|  | 120596-1 |

**MODEL: 371 XP**

**SUBJECT: Cylinder Base Gasket Part #503 64 37-01**

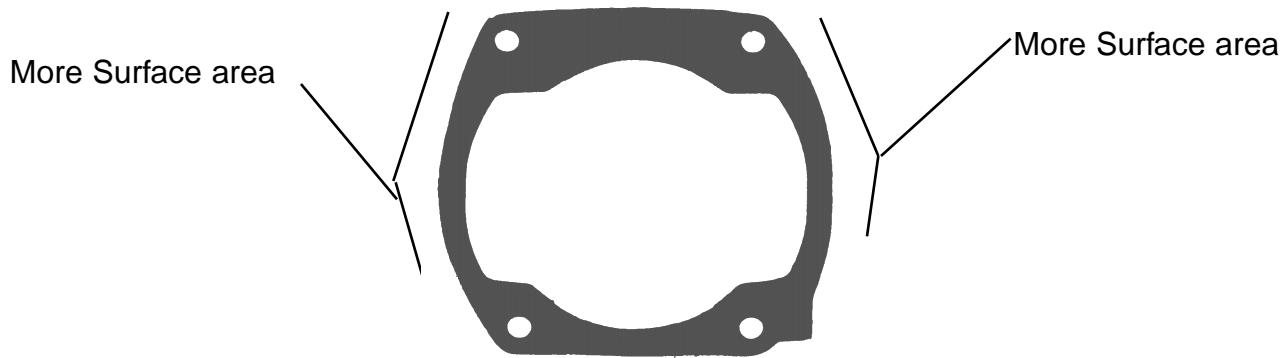
It has been reported that the cylinder gasket has been sucked into the crankcase in some areas around the country. This has been corrected by changing the base gasket to one that has more surface area as pointed out in the gasket below.

In some cases you can still use the old gasket along with a thin coat of gas and oil impervious RTV silicone to insure that it seals. The previous gasket is pictured below.
